MANDATORY SERVICE BULLETIN

Kodiak Rudder Closeout Fairing Clearance

Figure 1: Rudder Closeout Fairing

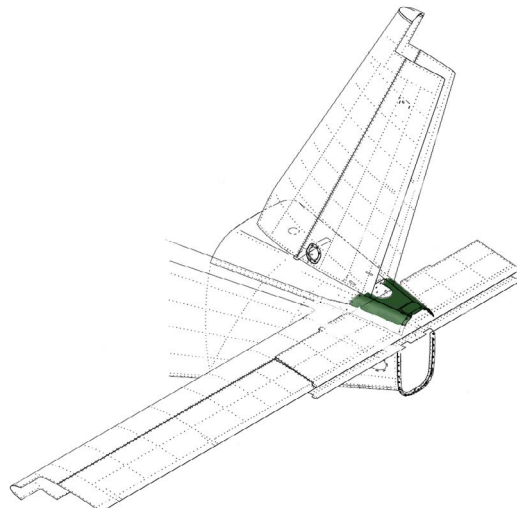
Affected Kodiak airplanes must be inspected to evaluate clearance between the Rudder Closeout Fairing and any adjacent aircraft structure. Damage may occur to the Vertical Spar and the Rudder Torque Tube Collar caused by rubbing from the Rudder Closeout Fairing. There should be a minimum 0.060" of clearance from the Rudder Closeout Fairing and any adjacent structure to prevent touch interference.

Inspect the perimeter of the Rudder Closeout Fairing for proper clearance. If an aircraft is found to have less than 0.060" of clearance from the Rudder Closeout Fairing and any adjacent structure, but is not contacting any structure, the fairing should be trimmed to accomplish 0.060" gap. If the fairing is contacting any structure and causing wear, please contact Kodiak Care for further guidance.
